650 MHz Cryomodule Section,  
FNAL Proposal,  
and some comments about the  
elevation of the warm-up line

31 May 2011

# Warm-up / cool-down line position

Cryomodule warm-up / cool-down line positions -- full liquid level

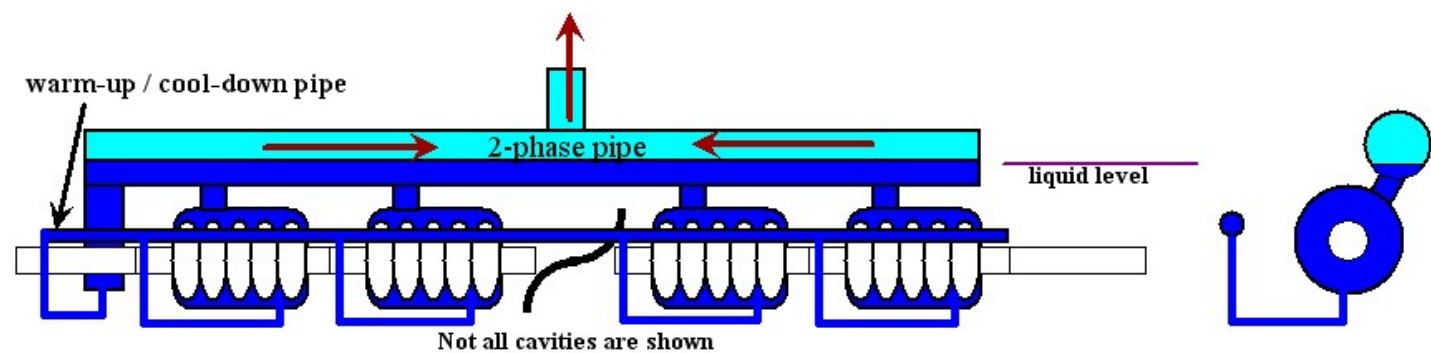
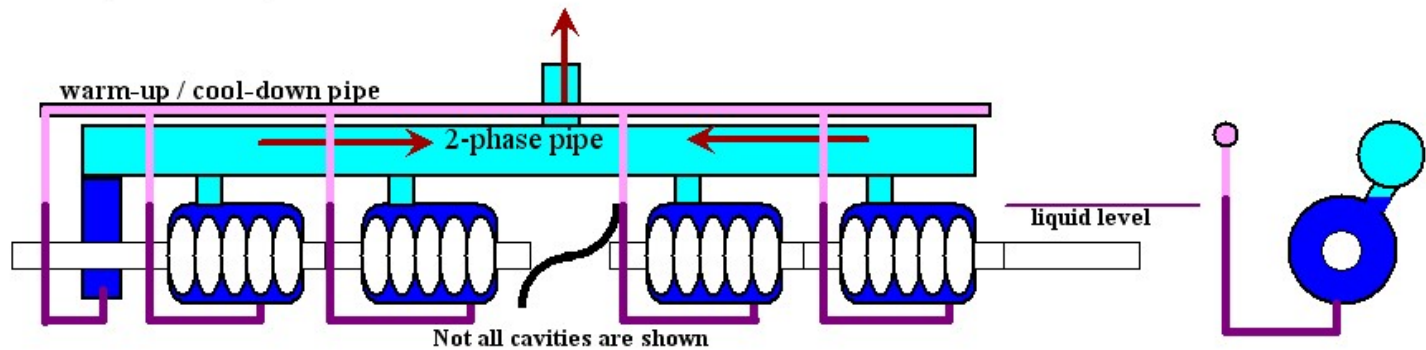
- There are two fundamentally different operational situations for a cryomodule depending on whether the warm-up / cool-down line (referred to as “warm-up line”) is above or below the helium vessel tops. The following two slides illustration the situations
  - Warm-up line above the helium vessels results in separated liquid levels in the helium vessels
  - Warm-up line below the helium vessel tops results in a common liquid level throughout the cryomodule when liquid is at or above the warm-up line level

Cryomodule warm-up / cool-down line positions -- low liquid level

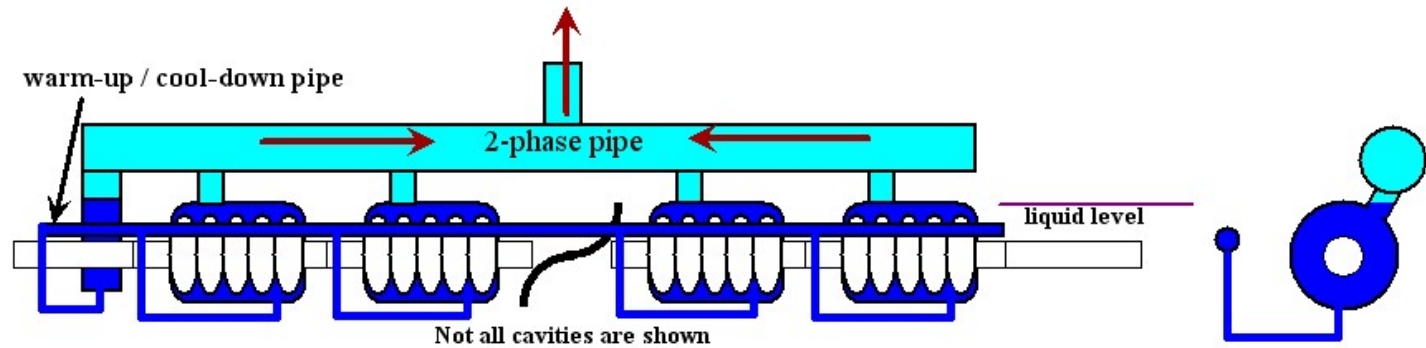
- For a sloped system, the warm-up manifold pipe should be ABOVE the liquid level at all times
  - Below, it would transfer liquid to the downhill helium vessels
- For a level system, one may take advantage of the warm-up pipe to provide a uniform liquid level through the cryomodule including when the liquid top is below the top of the cavity
  - Allows better control of the final stages of filling
  - Allows a liquid level measurement over a large range down into the helium vessels
